IEEE P802.15

Title: Transmit Center Frequency Tolerance for MR-FSK

Re: Task Group 15.4g LB59 comment resolution

Abstract: Comment resolutions related to MR-FSK PHY

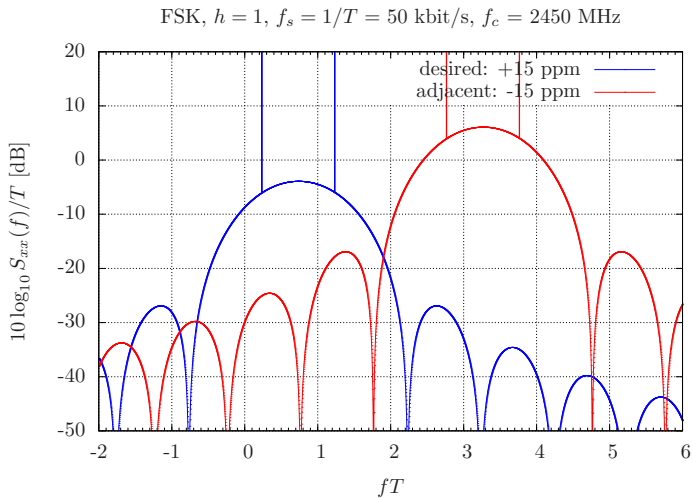
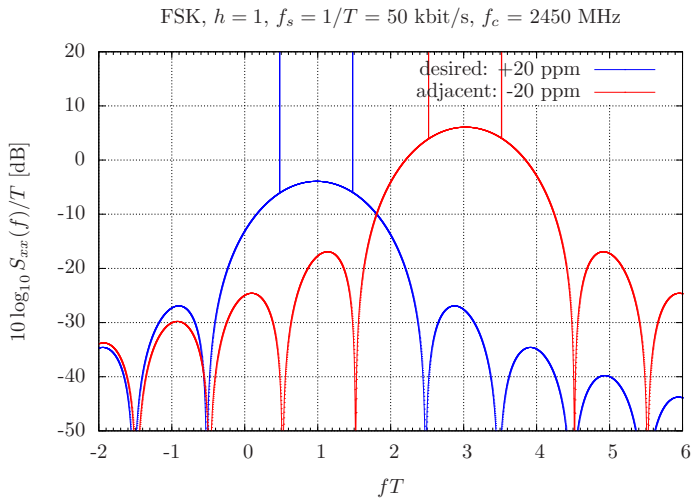
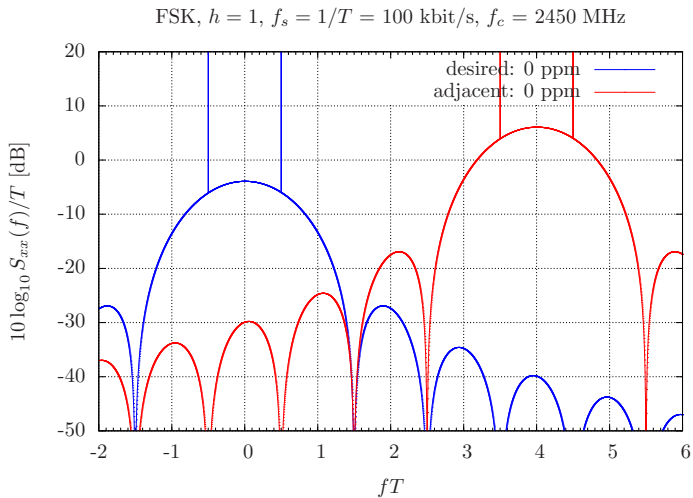
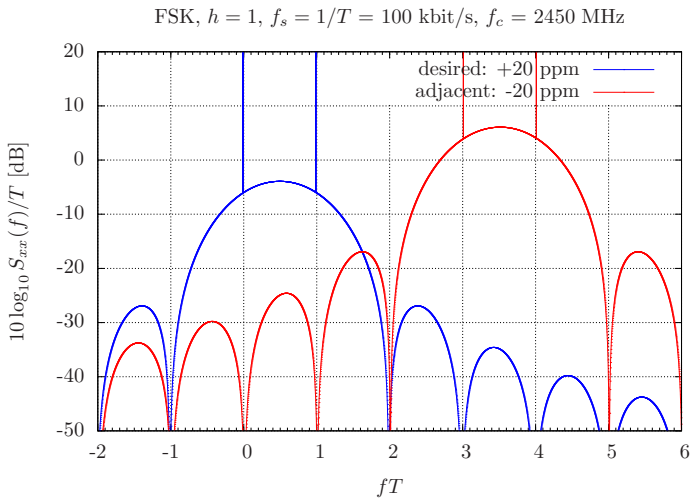
- ▶ At the 2400-2483.5 MHz band, the transmit center frequency tolerance is ± 15 ppm maximum for the mandatory mode (FSK, $f_s = 50$ kbit/s, $h = 1$).

- ▶ At the 2400-2483.5 MHz band, the transmit center frequency tolerance is ± 15 ppm maximum for the mandatory mode (FSK, $f_s = 50$ kbit/s, $h = 1$).
- ▶ This does not harmonize with the specification of the MR-OFDM and MR-O-QPSK PHY (both PHYs tolerate up to ± 20 ppm).

- ▶ At the 2400-2483.5 MHz band, the transmit center frequency tolerance is ± 15 ppm maximum for the mandatory mode (FSK, $f_s = 50$ kbit/s, $h = 1$).
- ▶ This does not harmonize with the specification of the MR-OFDM and MR-O-QPSK PHY (both PHYs tolerate up to ± 20 ppm).
- ▶ Compared to the tolerance of ± 40 ppm (IEEE-802.15.4-2006), even the required ± 20 ppm will add noticeable costs for test, calibration and board design.

- ▶ At the 2400-2483.5 MHz band, the transmit center frequency tolerance is ± 15 ppm maximum for the mandatory mode (FSK, $f_s = 50$ kbit/s, $h = 1$).
- ▶ This does not harmonize with the specification of the MR-OFDM and MR-O-QPSK PHY (both PHYs tolerate up to ± 20 ppm).
- ▶ Compared to the tolerance of ± 40 ppm (IEEE-802.15.4-2006), even the required ± 20 ppm will add noticeable costs for test, calibration and board design.
- ▶ Hence, care should be taken with regard to the transmit center frequency tolerance.

- ▶ The MR-FSK PHY mandates at least 10 dB adjacent channel rejection.
- ▶ However:
 - ▶ The requirements on the spectral mask are quite relaxed.
 - ▶ There is no processing gain.
 - ▶ There is no coding gain for the mandatory modes.
 - ▶ There influence due to clock frequency tolerance is quite substantial.
- ▶ Though the specification are consistent with regard to the receiver jamming resistance (see section 6.12a.4.3, assuming an unmodulated carrier at a fixed offset), there will be moderate adjacent channel rejection in practical applications at 2400-2483.5 MHz.

- ▶ Harmonize clock frequency tolerance to ± 20 ppm.

- ▶ Harmonize clock frequency tolerance to ± 20 ppm.
- ▶ Consider a channel spacing of 400 kHz (still supporting ≥ 75 hopping channels).

- ▶ Harmonize clock frequency tolerance to ± 20 ppm.
- ▶ Consider a channel spacing of 400 kHz (still supporting ≥ 75 hopping channels).
- ▶ Consider a higher symbol rate

| frequency band (MHz) | channel spacing (kHz) | h | f_s (kbit/s) | max. Tol (ppm) |
|-------------------------|----------------------------------|-----|---------------------------------|---|
| 2400-2483.5 | 200 \rightarrow 400 | 1 | 50 \rightarrow 100 | ≈ 15 \rightarrow ≈ 20 |
